October 20, 2023

Butte College Mechanized AG Relocatable Construction Observation Report Date of site visit: August 19, 2023

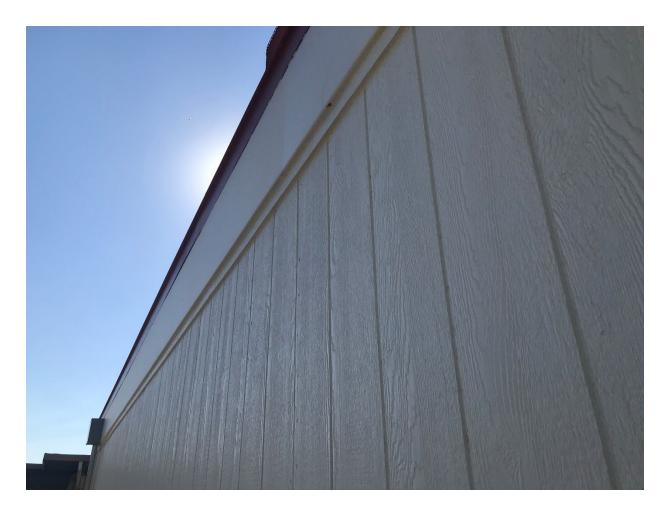
Install Egress light as shown on sheet E2.3. This light is to be located on the east side of portable IPH:

In grade box that allow access to portable ground rod for portable IPI is well below grade.

Raise box to finished grade heigh:

Seal all holes where previous liquid tight flex clamps were installed. Verify on all portables.

Recommend installing a new/additional clamp(s) to make installation less likely to incur any damage from externally applied forces. (No code violation).
